**RE: Weinerschnitzel
1400 Gibson Blvd SE
Grading Plan
Engineer's Stamp Date: 7/17/18
Hydrology File: L15D049**

Based on the submittal received on 7/18/18, the grading plan is approved for Foundation Permit Only.

GRADING & DRAINAGE PLAN

SECTION A-A

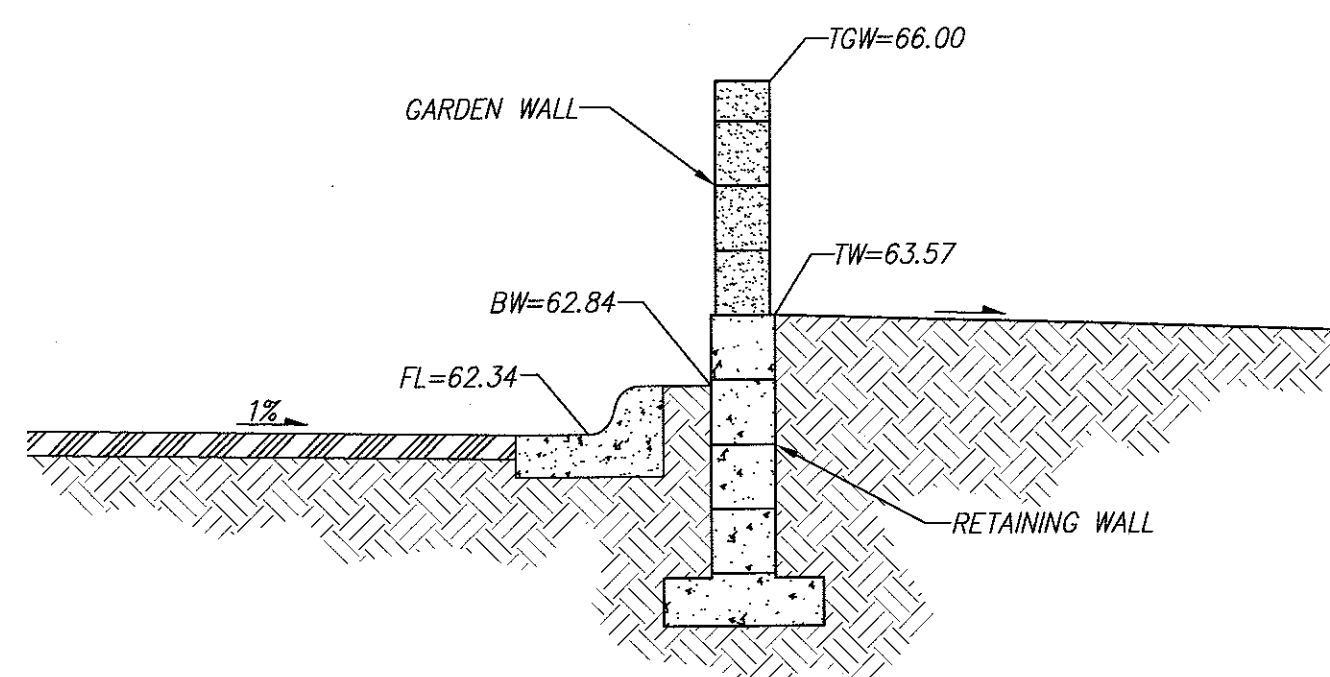
3. The fee-in-lieu should be calculated from the required first flush volume (53cf) not the total size of the pond. Please correct the calculations.
4. Payment of the Fee in Lieu (Amount = 53CF x \$8/CF, per the grading and drainage plan) for the required first flush volume must be made.

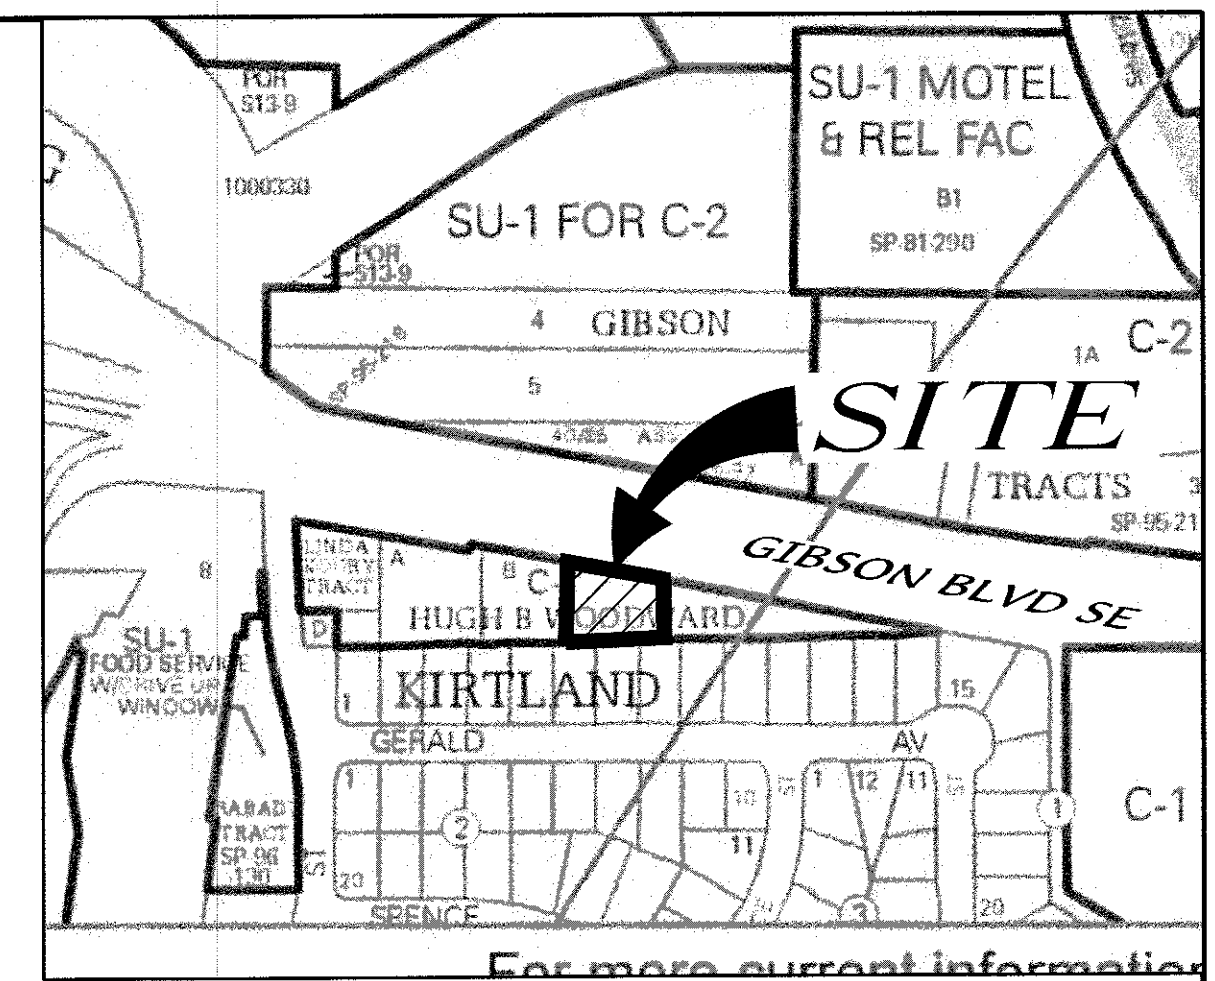
1. Show and label the ROW line on the plan view and the wall section. Any private encroachment into the public ROW by the retaining/garden wall or its footer requires a revocable permit. The complete permit and fees must be turned into DRC (4th, Plaza del Sol) for routing. Please contact Charlotte LaBadie (clabadie@cabq.gov, 924-3996) or Madeline Carruthers (mtafoya@cabq.gov, 924-3997) regarding the routing and recording process for revocable permits.

2. For trash enclosures serving food service developments, demonstrate *control of liquids from dumpster areas* per DPM Chapter 22.9.E, Table 1 by containing runoff from the dumpster area and discharging to the sanitary sewer. If this information is on the utility plan please provide it, or show on the grading plan.
